## HISTORIC AND DESIGN REVIEW COMMISSION

**HDRC CASE NO:** 2018-357  
**ADDRESS:** 407 MISSION ST  
**LEGAL DESCRIPTION:** NCB 946 BLK 2 LOT 20  
**ZONING:** RM-4,HS  
**CITY COUNCIL DIST.:** 1  
**DISTRICT:** King William Historic District  
**LANDMARK:** Wharton House  
**APPLICANT:** Jerry Woolf/JB Woolf Sheds  
**OWNER:** Justin Solomac  
**TYPE OF WORK:** Construct detached garage in rear yard  
**APPLICATION RECEIVED:** July 12, 2018  
**60-DAY REVIEW:** September 11, 2018  
**REQUEST:**

The applicant is requesting a Certificate of Appropriateness for approval to construct a detached carport in rear yard.

**END WALL ELEVATION WITH OPENING**  
SCALE: 1/4" = 1'-0"

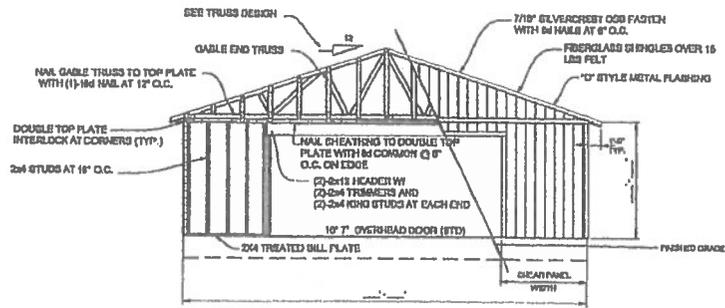
- g. **GARAGE DOOR** – Per the Guidelines for Garages and Outbuildings 5.A.v, garages doors should feature similar proportions and materials as those traditionally found in the district. Staff finds that the double-wide garage door is not historically found in the district and instead should feature two bays with single-width garage doors.

- i. That windows and fenestration details that are consistent with the Guidelines are incorporated into the side elevations.
- ii. That the garage feature two bays of single-width garage doors instead of the proposed double-wide garage door.
- iii. That the structure feature wood or hardi lap siding and a standing seam metal roof instead of the proposed shingle roof. The metal roof must adhere to the following stipulations: panels should be 18-21 inches wide, seam should be 1-2 inches tall and appropriate to the slope of the roof, a crimped ridge seam that is consistent with the historic application, standard galvalume color. Vented ridge caps are not to be used, and a low profile ridge cap/v-crimp panels will require HDRC approval.
- iv. The applicant is furthermore responsible for complying with any building setback requirements per the UDC for the garage.

**SIDE WALL ELEVATION WITH OPENINGS**  
SCALE: 1/4" = 1'-0"

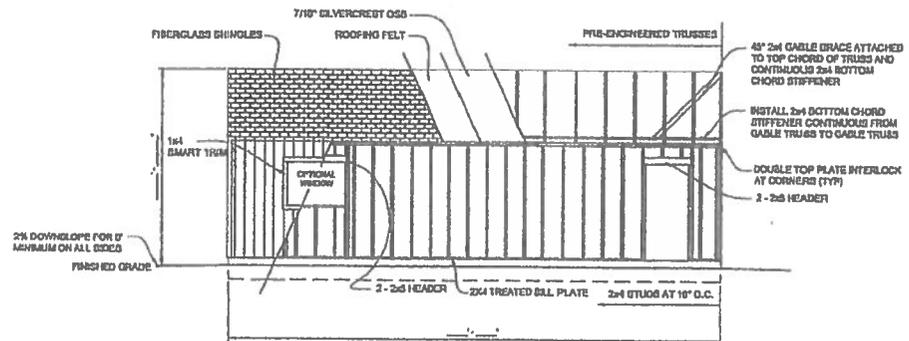
- f. **WINDOWS & DOORS** – Per the Guidelines for Garages and Outbuildings 5.A.iv, windows and door openings should be similar to those found on the historic garages or outbuildings in the district or on the principal historic structure in terms of spacing and proportions. Staff finds the side door featuring 3 by 3 divided lights and traditional paneling is consistent with the Guidelines. However, staff also finds that the lack of fenestration and windows is not consistent with Guidelines or other historic garages in the district. Staff finds that fenestration should be incorporated into the side elevations.
